Staff Report & Recommendation

Historic Preservation Board

SUBJECT: HPB17-0099, **947 Lincoln Road.**

Existing Lincoln Road and corner elevation drawings, L. Murray Dixon, 1938.

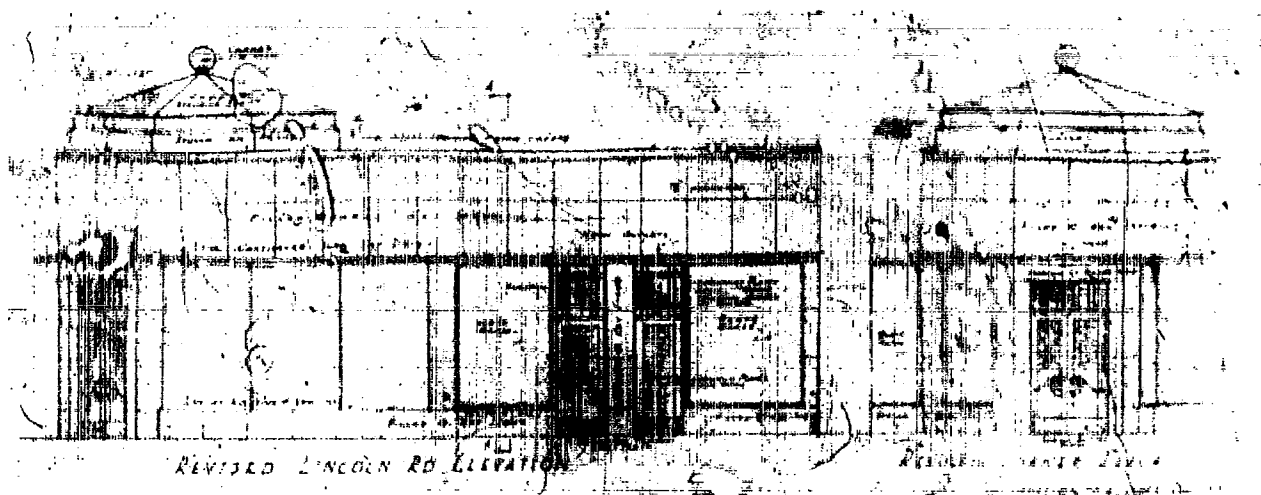
In 1938, the Lincoln Road façade was ‘modernized’ in the Streamline Moderne style of architecture by L. Murray Dixon. These alterations (see elevations below) included the introduction of a copper roofed cupola at the corner, projecting eyebrow, filled keystone cladding, and new storefront showcase windows built-out approximately 2'-0" towards Lincoln

Road. The rear approximately 85% of the building was not altered. Since 1938, the facades of the building have remained relatively intact with the exception of minor alterations within the bay openings and the removal of the decorative dome in 1956.

- b. The Lincoln Road façade and corner shall be restored to the greatest extent possible consistent with the 1938 Dixon design, including the reintroduction of the copper clad cupola. The remainder of the facades shall be restored to the greatest extent possible consistent with the original 1924 design, in a manner to be reviewed and approved by staff consistent with the Certificate of Appropriateness Criteria and/or the directions from the Board.
